Re: Turkey Point Units 3 and 4  
Docket Nos. 50-250 and 50-251  
Response to NRC Request for Additional Information (RAI) Regarding Extended  
Power Uprate (EPU) License Amendment Request (LAR) No. 205 and Unit 4  
Mechanical/Civil Engineering Issues and Correction to Turkey Point Unit 3 Response  
Submitted by FPL Letter L-2011-102, Accession No. ML110880060, March 25, 2011

RESPONSE TO NRC RAI REGARDING EPU LAR NO. 205  
AND UNIT 4 EMCB MECHANICAL/CIVIL ISSUES

Response to Request for Additional Information

Figure 1

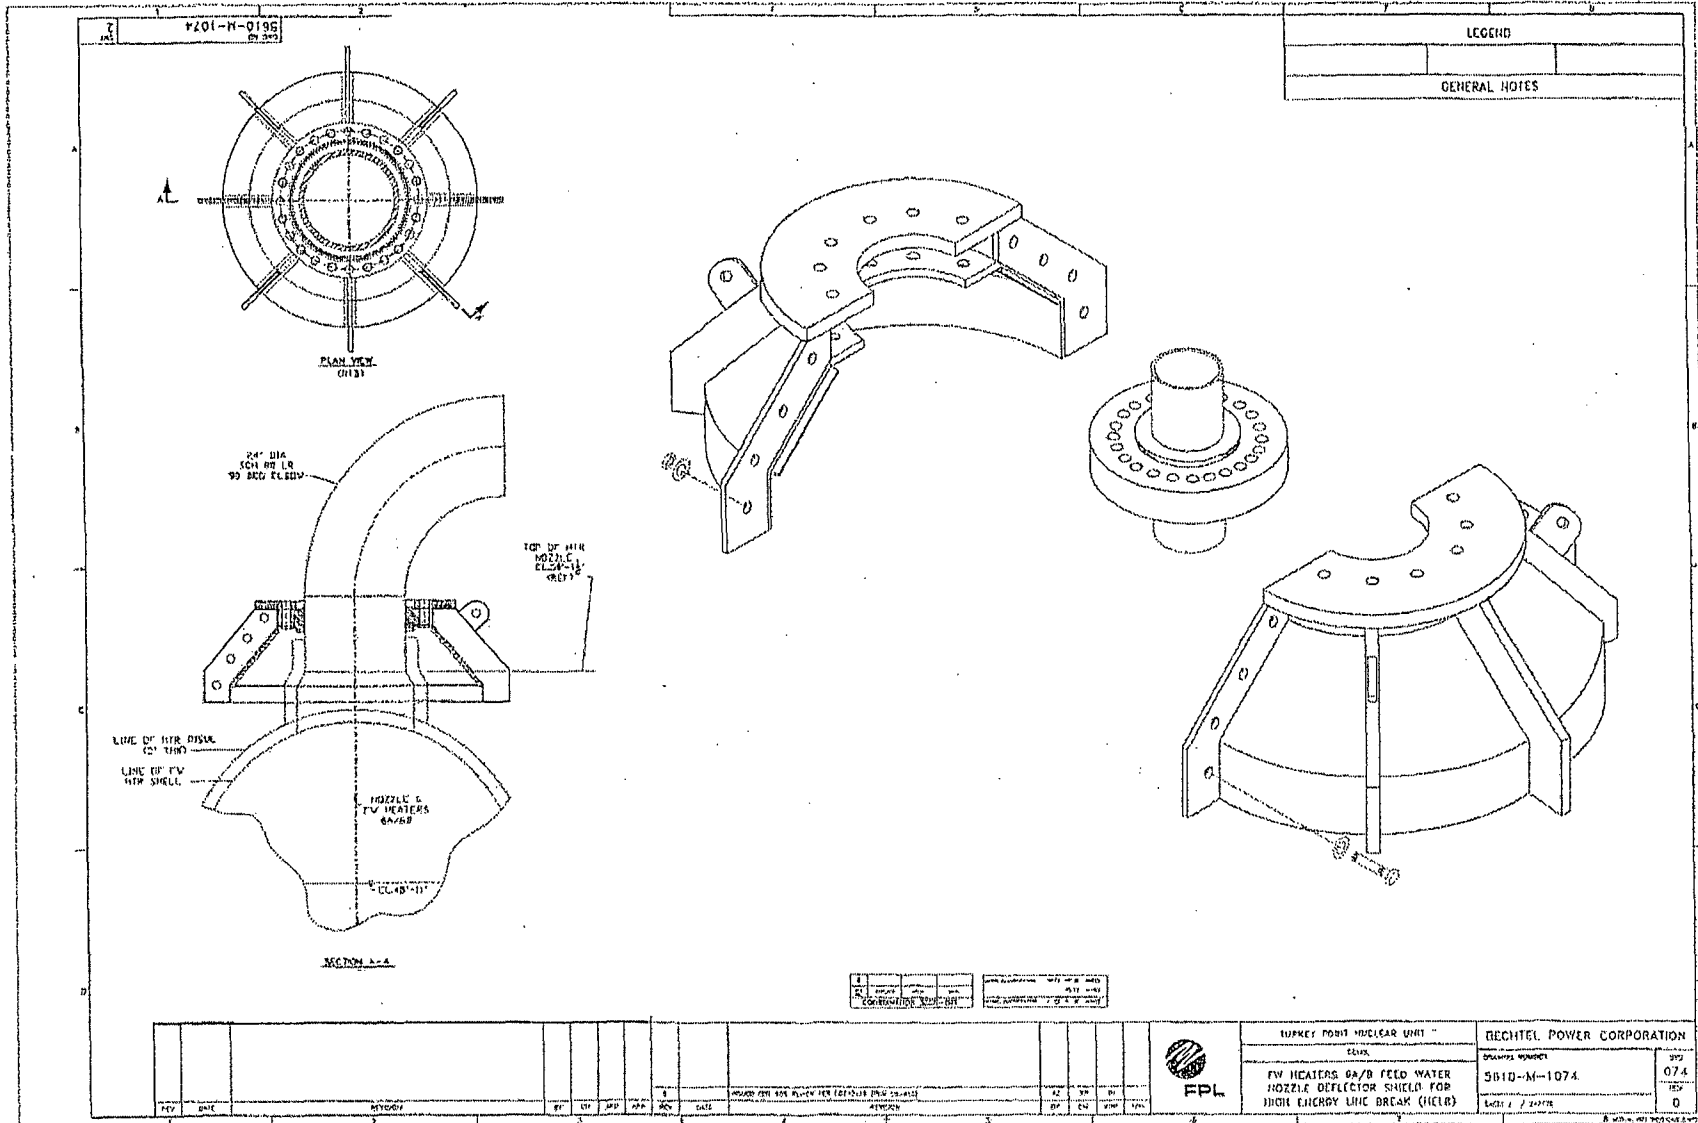
- 3. In Section 2.5.1.3.2.3.4 (Attachment 4, Licensing Report) the licensee notes the replacement of the 6<sup>th</sup> feedwater heaters will result in resizing of the discharge piping from 18 inches to 24 inches. The jet impingement zones of influence are increasing due to EPU requiring modifications to shield equipment important to safety. These statements indicate that the evaluations (design and analysis) of 24 inch discharge piping, and shield equipment required to support the EPU have not been performed yet. Therefore, the licensee has not provided sufficient technical information for staff's review to determine whether reasonable assurance exists to conclude that the integrity of the required modifications are structurally adequate for the proposed EPU.**

Two of the terminal end break locations for the main feedwater (FW) piping are at the outlet of the PTN Unit 4 E6A/B FW Heaters. Due to increase of the FW Heater outlet nozzle diameter to 24 inches from the current outlet nozzle diameter of 18 inches, there is an associated increase in the size of the pipe break zone of influence. The calculated zone of influence for EPU conditions is 18 ft. for the postulated break (increased from 13.5 ft.). The impact to components important to safety from the increased jet impingement zone of influence has been evaluated in the PTN design change process for the replacement of the number 6 FW Heaters in PTN Unit 4. Walkdowns encompassing an 18 foot zone of influence around the number 6 FW Heater outlet pipes have been performed to identify equipment important to safety. Safety-related pressure transmitters PT-4-464, PT-4-476, PT-4-486, PT-4-496, and PT-4-2604 may be influenced by a circumferential FW pipe rupture at the outlet nozzle terminal ends because of their close proximity to the number 6 FW Heaters HELB zone of influence. These components are located within the main steam valve platform trestle area.

To protect these components, new deflector shields will be installed on the FW outlet piping at the postulated circumferential break locations at each of the number 6 FW Heater outlet nozzles. The shields are designed to redirect jet forces and guide streams in a direction away from the safety-related equipment. The design of the HELB deflector shield is shown in Figure 1.

The design and analytical details for the HELB deflector shield for PTN Unit 4 were completed, and will be incorporated into the FW system modification package. The deflector shields are designed as Class III Structures, Systems, and Equipment, but using the same design allowable stresses as those used for Class I Structures, Systems, and Equipment defined in Appendix 5A of the PTN Updated Final Safety Analysis Report (UFSAR) since the criteria for Class III does not include provisions (allowables) for faulted conditions.

Principal stresses were calculated using standard structural finite element method techniques, under various scenarios of applied loading, from the postulated terminal end break. The maximum principal stresses were determined to be less than the stress limits defined in Appendix 5A of the PTN UFSAR for hypothetical accident conditions. As such, no loss of function is assured.
